Item 4.**Development Application: 107-109 Darlinghurst Road, Potts Point - D/2025/1026****File Number:** D/2025/1026**Summary****Date of submission:** 27 October 2025 (Amended plans received: 27 May & 21 August 2026).**Applicant:** Mr Peter McGregor**Architect/Designer:** McGregor Westlake Architecture**Owner:** Raben Footwear Pty Ltd**Planning consultant:** Daintry Associates Pty Ltd**Heritage consultant:** Zoltan Kovacs**Cost of works:** \$10,234,400.00**Zoning:** E1 - Local Centre

Proposal summary: Consent is sought for alterations and additions to an existing mixed-use building above Kings Cross Station, including construction of 2 additional levels.

Figure 36: Plan and view from sun diagrams for private open space of Omnia building residential apartments at 9am, 21 June

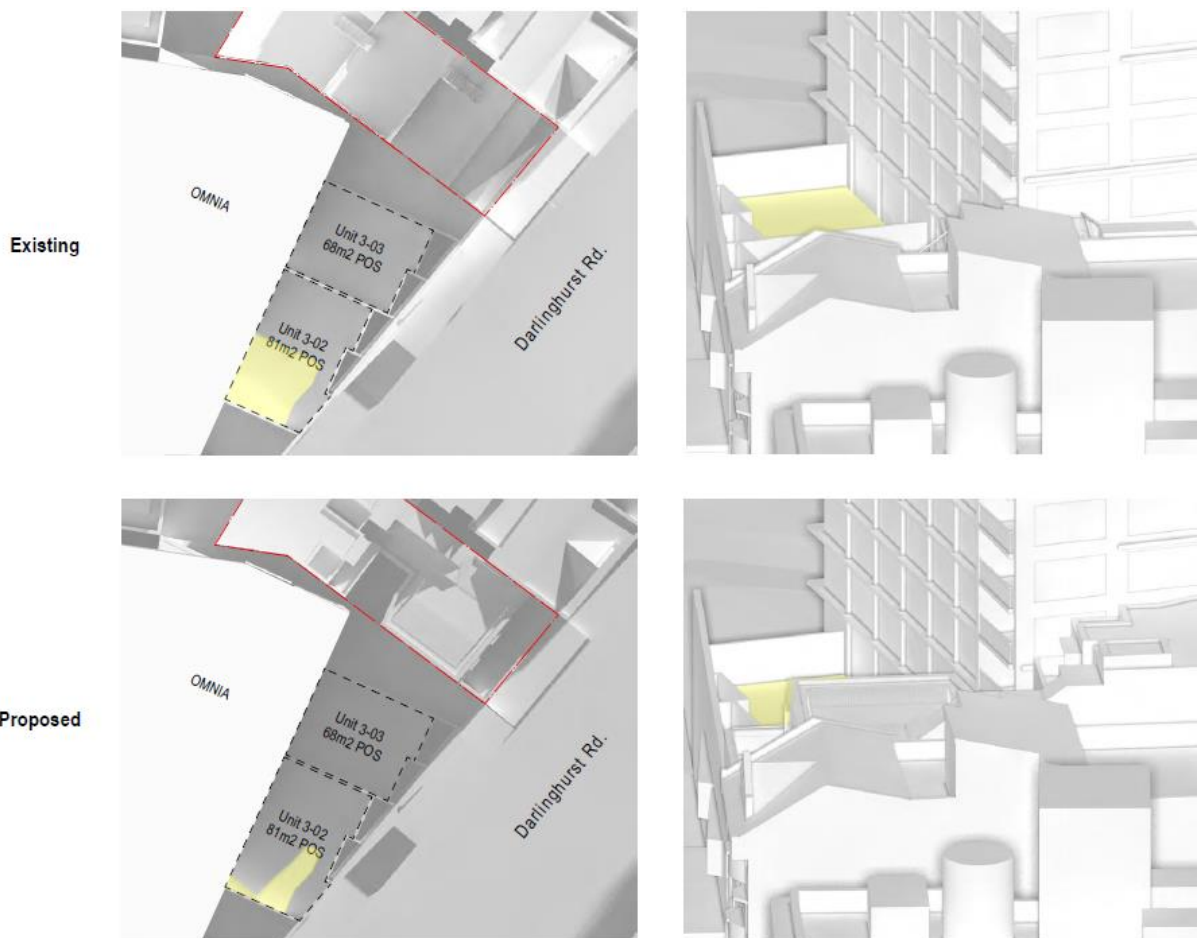
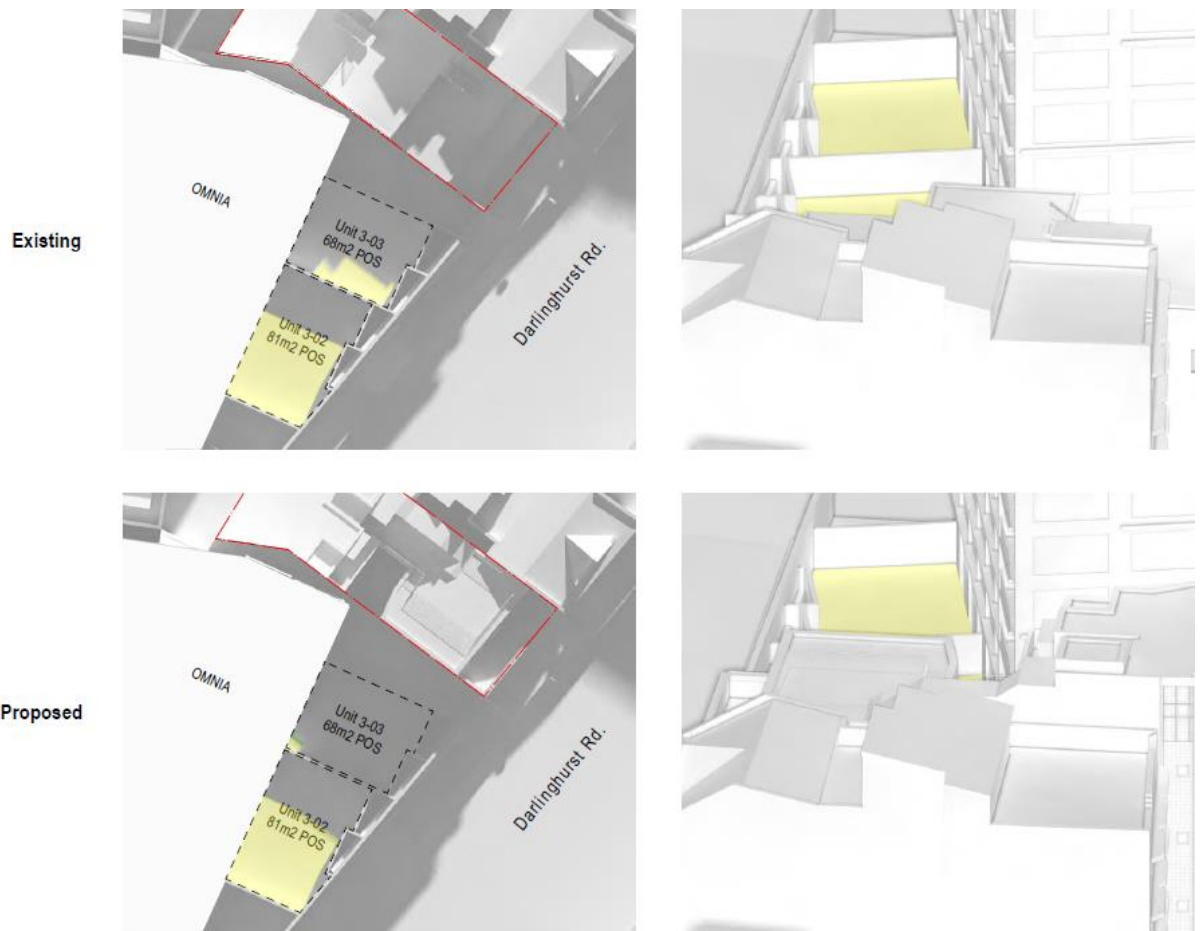
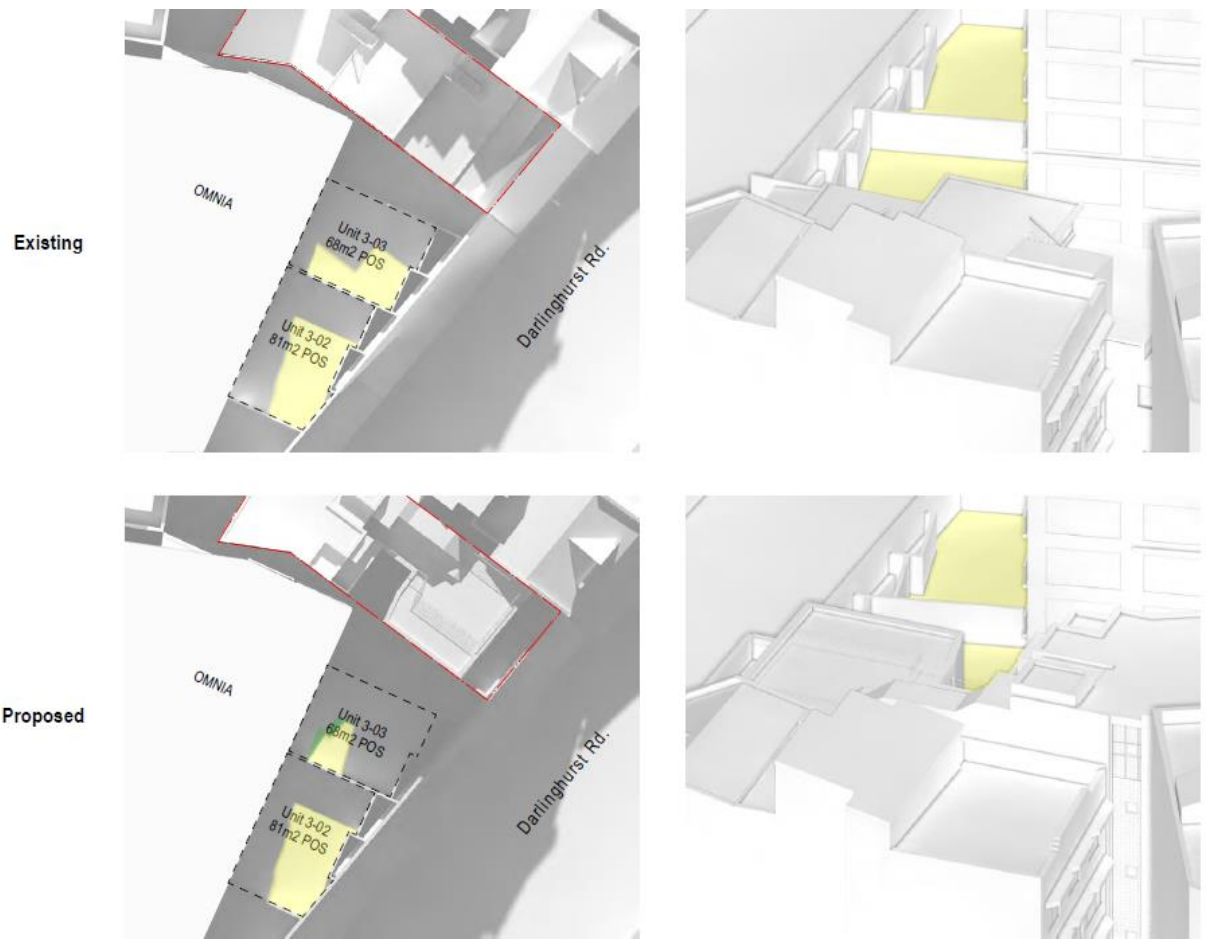
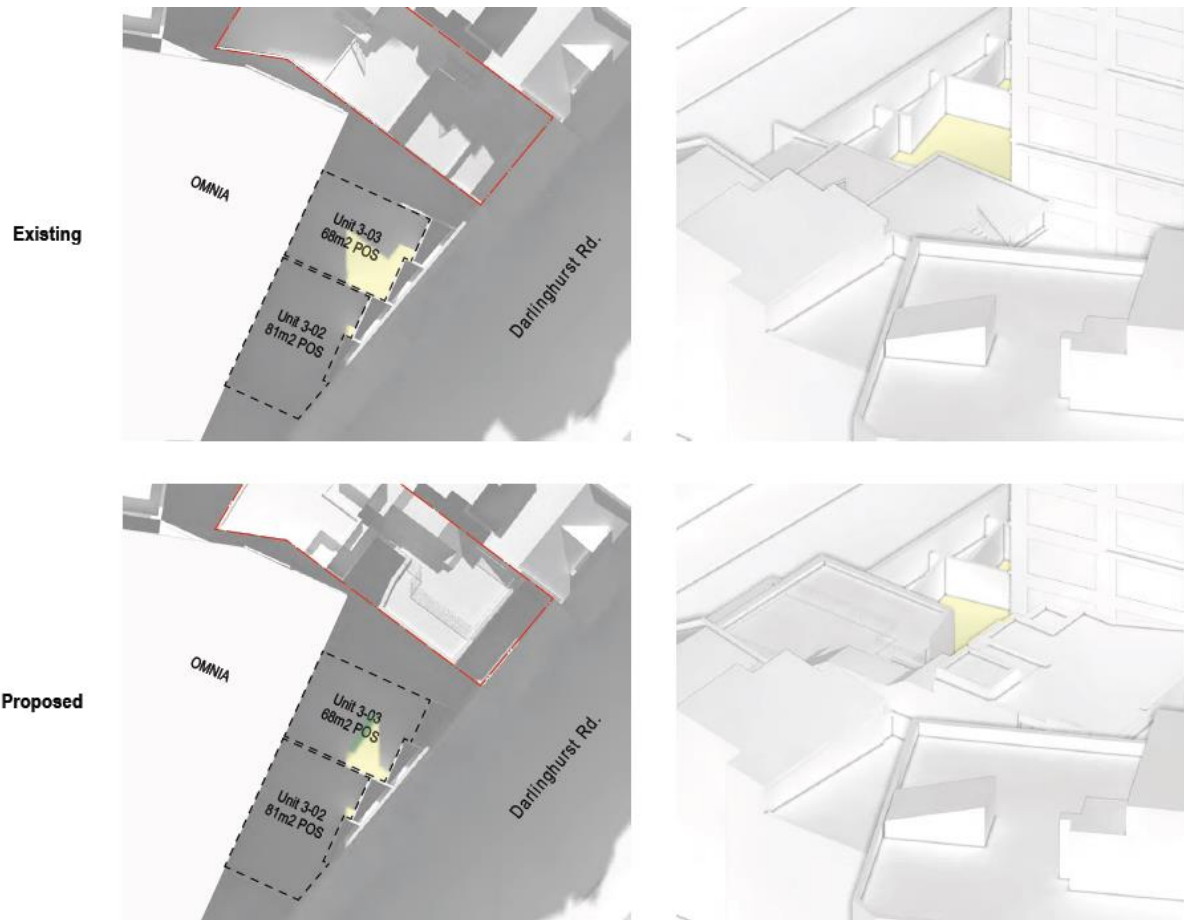
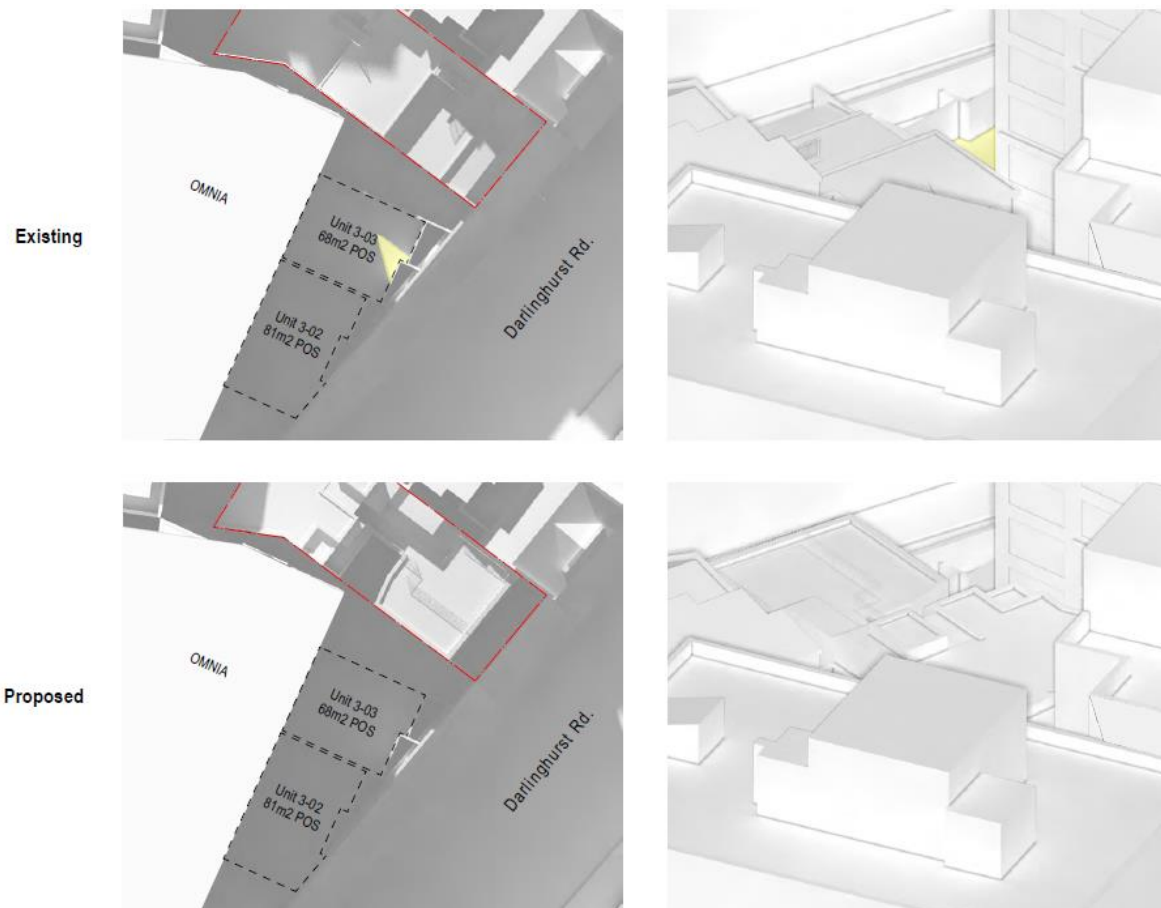
95. The private open space terrace area of Unit 3-03 on the podium level of the Omnia building currently receives 2 hours' direct sunlight between 9am and 11am on 21 June.
96. As Unit 3-03 is a 2-bedroom apartment, the required minimum amount of private open space provision is 10 square metres in accordance with the provisions of Section 4.2.3.7(6) of the DCP and Objective 4E-1 of the NSW ADG.
97. Accordingly, the minimum solar access requirement to this terrace area is 2 hours' direct sunlight to at least 5 square metres, as this is 50% of the minimum required area pursuant to Section 4.2.3.1 of the Sydney DCP.

98. Whilst the applicant has not provided dimensions to measure existing solar access to this space, it is noted that the terrace measures 68 square metres and it is considered that the terrace will achieve the minimum 5 square metres' direct sunlight for at least 2 hours as existing.
99. The proposed development and additional two levels proposed atop of the existing building will block reduce direct sunlight to this private open space area from 9am to 1pm on 21 June, resulting in a non-compliance with the solar access requirements of the DCP.
100. Overshadowing impacts to the adjacent private open space terrace areas of the Omnia building are demonstrated by Figures 36-40 below, with the terraces of Unit 3-02 and Unit 3-03 highlighted in yellow, and any impacts directly attributed to the maximum building height exceedance highlighted in green.
